PARTS & SERVICE NEWS

REF NO.	AT00006B
DATE	Apr. 11, 2001

SUBJECT: REPAIR OF DEFECTIVE STARTING MOTOR (SAFETY RELAY) ON PC60/70-7 ETC.

PURPOSE: To introduce modification procedures to remedy malfunctioning of the starting motor (due to defective safety relay) on PC60-7, PC70-7 and other models of hydraulic excavators

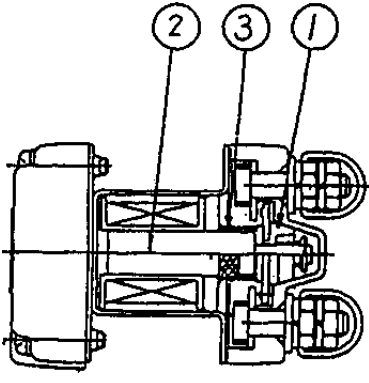
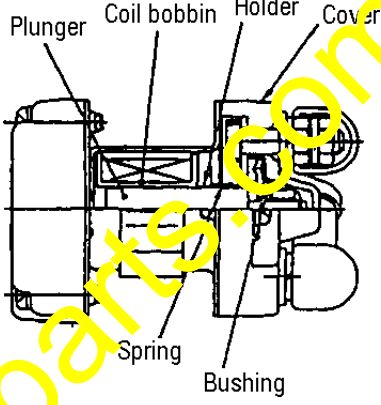
An internal part of the safety relay may wear to cause the operating voltage of the relay to increase, leading to occurrences of activation failures of the starting motor.

The cause for this failure is that the bushing used inside the safety relay has worn by rubbing against the cover and sliding resistance has increased.

As the improvements to remedy the above failure and, simultaneously, as a means to prevent the spring from entering into inside the holder, following modifications have been implemented.

New safety relay		Current safety relay	
Structures				
	Changes made	New part	Current part	Purpose of the improvement
①	Material of the bushing	Duracon (M90-44)	Fiberglass reinforced Duracon	To improve the vibration resistance (9G → 20G)
②	Surface treatment for the plunger	Tufftride	Zinc plating	To improve the vibration resistance (9G → 20G)
③	Spring holder	Supplemented an L-shaped washer	None	To prevent damage by the spring

4. Identification method for the improved part

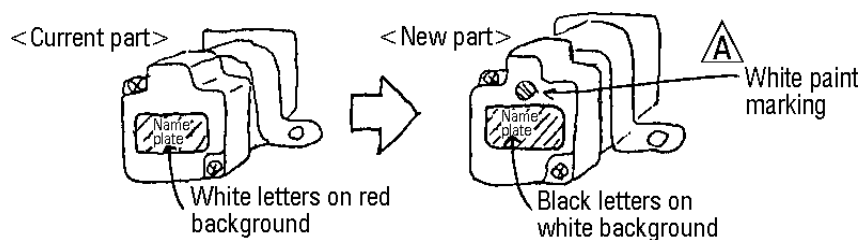
<Current part> 0-25000-7960 → <New part> 0-25000-7961 (600-815-8940)

<Current part> 0-25000-7410 → <New part> 0-25000-7411 (600-815-8930)

Also, pursuant to the manufacturer's part number change, the color of the nameplate has been changed.

Also, pursuant to the part number change by the manufacturer, the color of the nameplate has been changed and, also, a white paint marking is being provided above the nameplate for the identification purpose.
